Chapter 11 Radioactive Waste Management

This section of the referenced DCD is incorporated by reference with the following departures and/or supplements.

Figure 11.4-1R Solid Waste Management System Process Diagram [EF3 DEP 11.4-1]

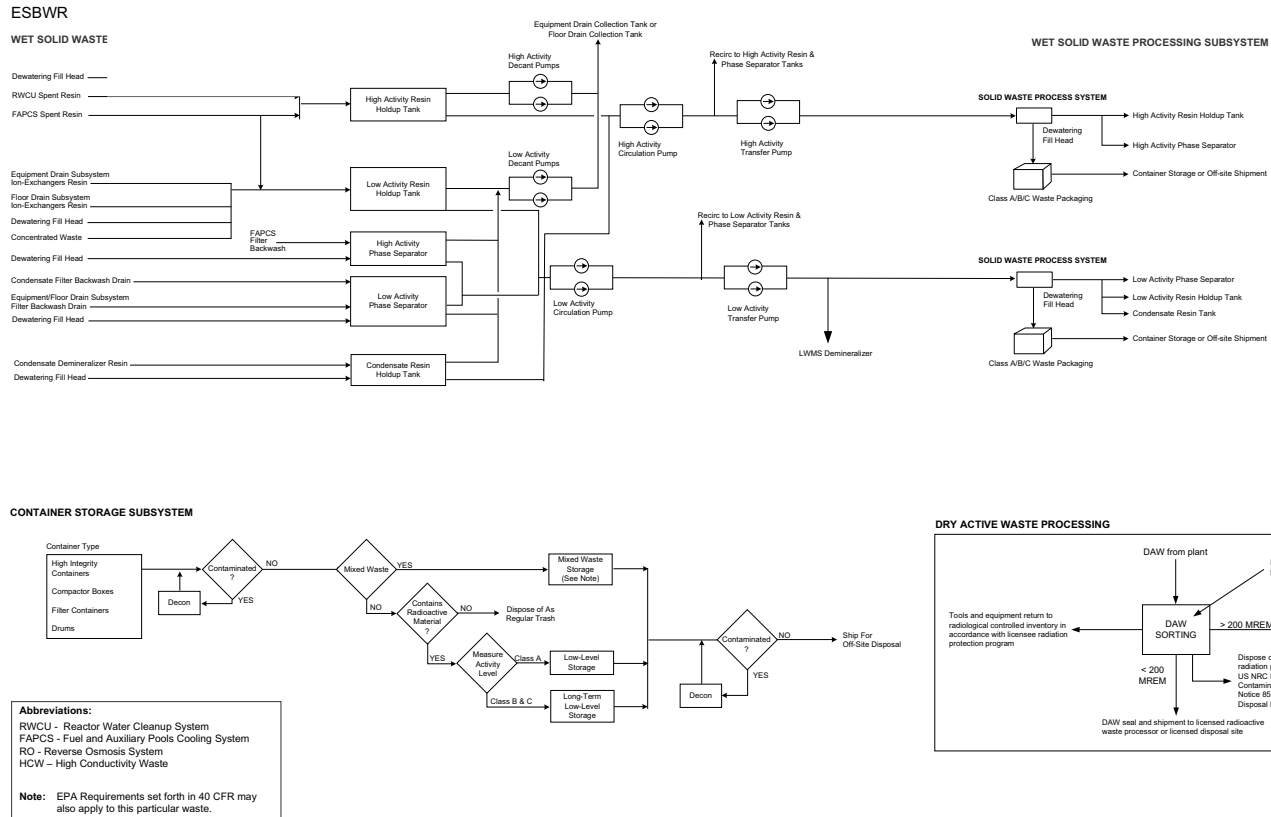
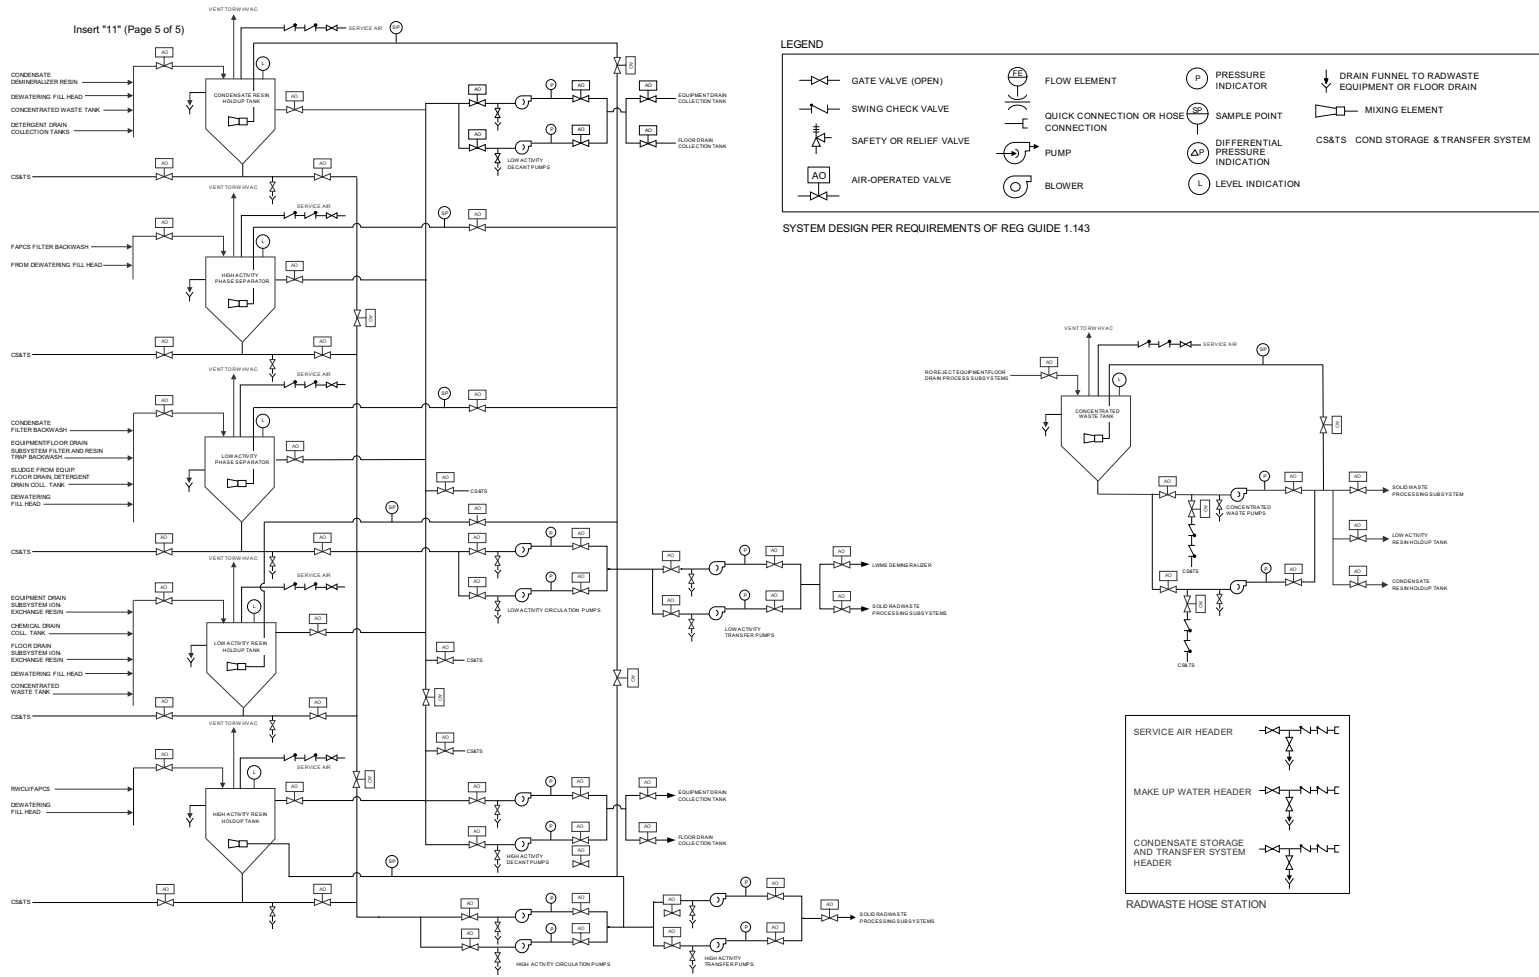
When sufficient bead resins have been collected in the high or low activity resin holdup tanks, they are mixed via the high or low activity circulation pump and sent to the SWMS Processing Subsystem via the high or low activity transfer pump. When sufficient bead resins have been collected in the condensate resin holdup tank, they are mixed via the low activity circulation pump and sent to the LWMS pre-treatment

ion-exchanger for reuse or the SWMS Processing Subsystem via the low activity transfer pump.

The suspended solids are allowed to settle and the residual water is transferred by the respective decant pump to the equipment drain collector tanks or the floor drain collector tanks for further processing. When sufficient sludges have been collected in the tank, the sludges are normally mixed by the low activity circulation pump and sent to the SWMS Processing Subsystem by the low activity transfer pump.
